Changes to the Draft EIS that, combined with the Draft EIS, constitute the Final EIS for the Condon Wind Project.

Figure 2.1-3
Turbine Features, 600-KW

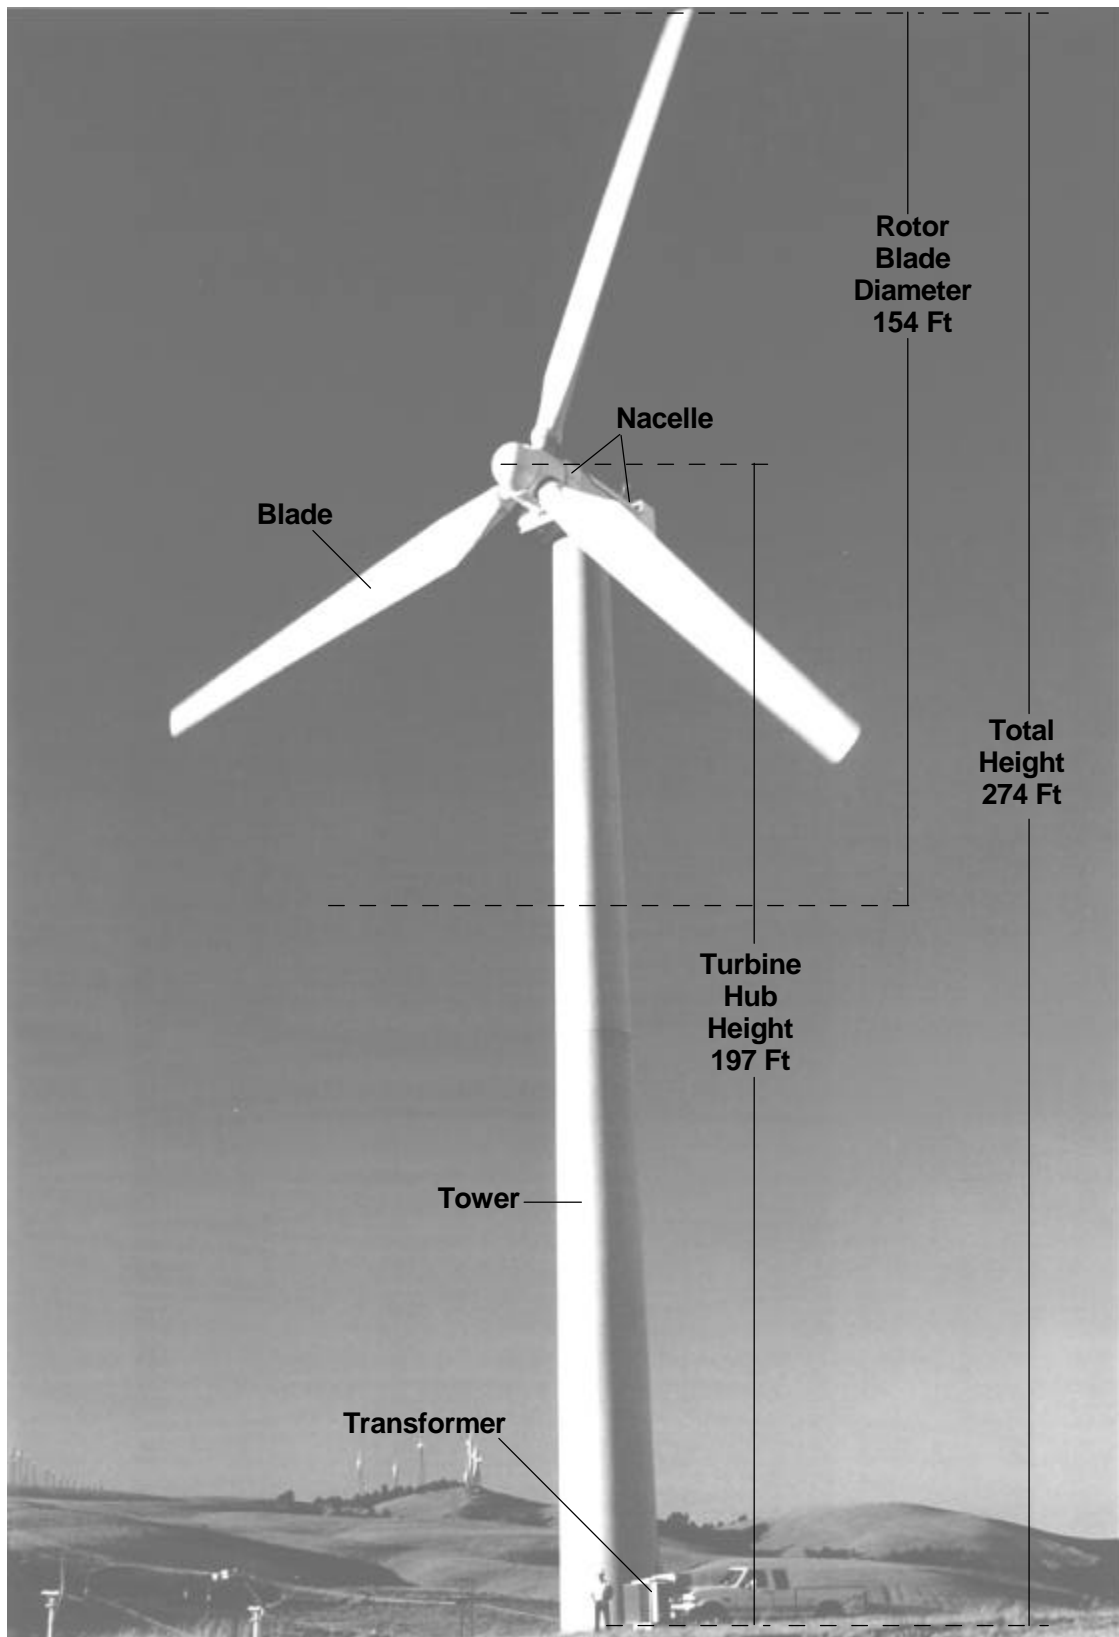
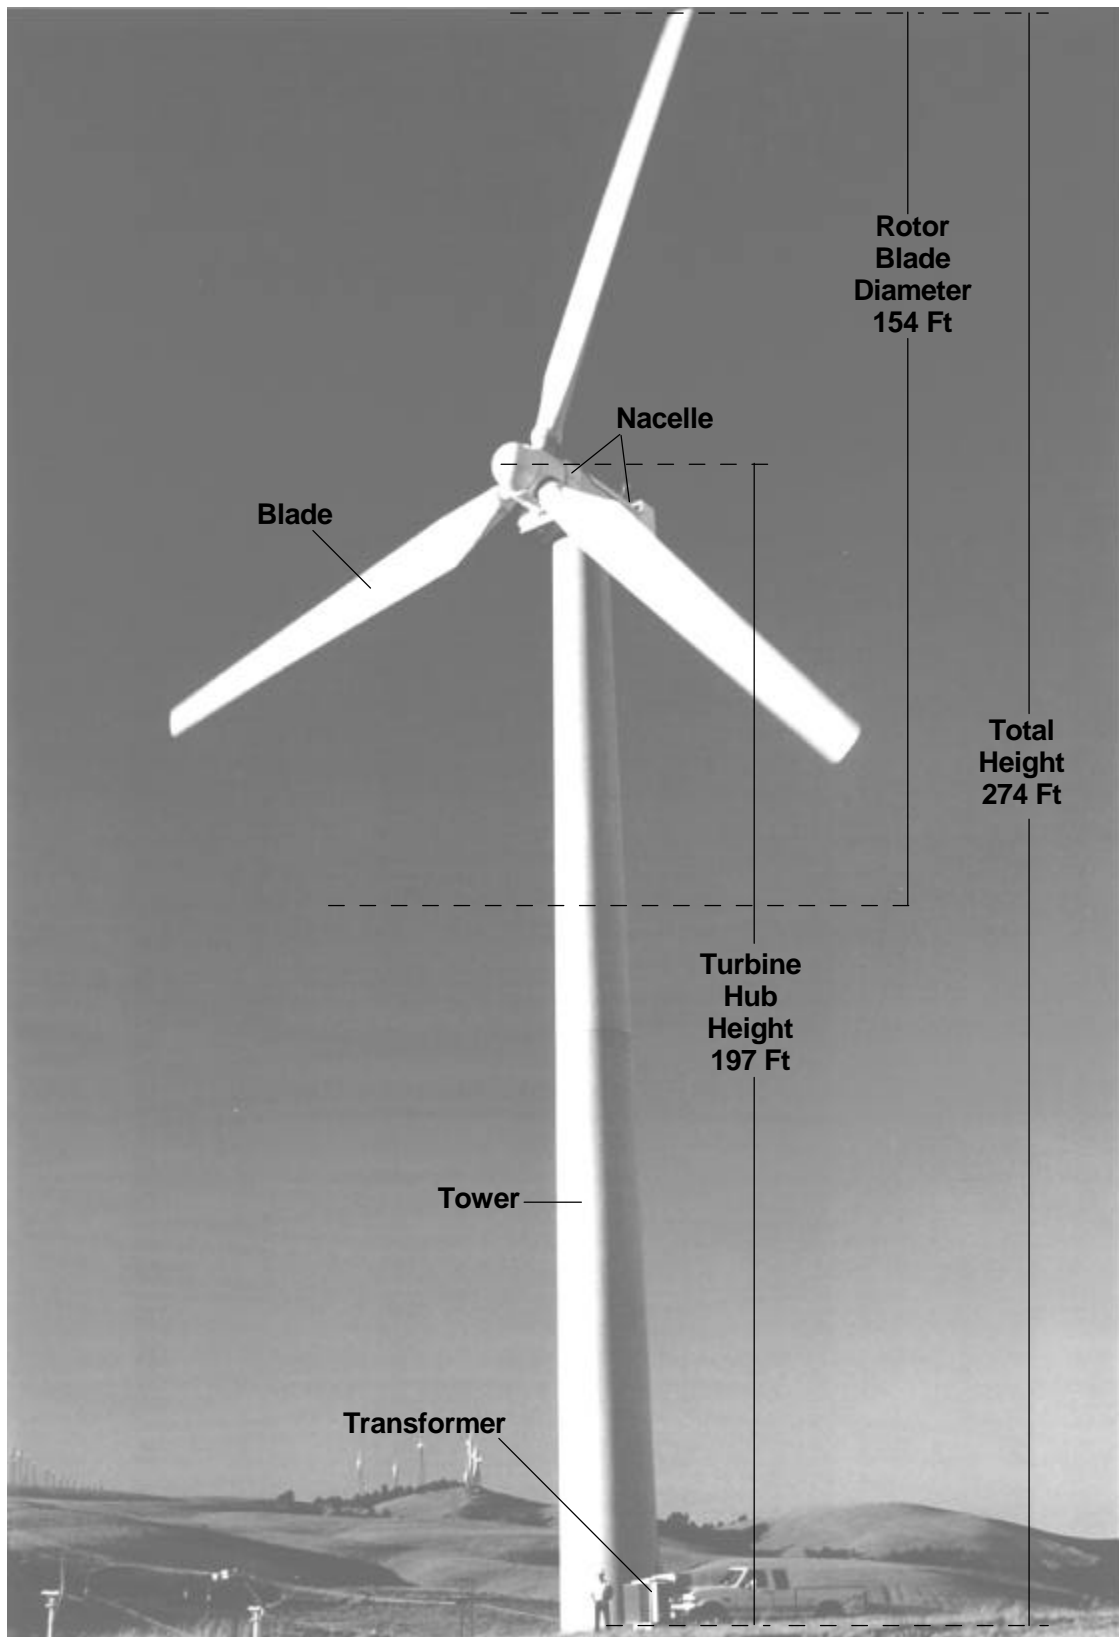
[AMEND DEIS] Figure 2.1-3—Turbine Features, 600 kW, replace with figure that follows this page.
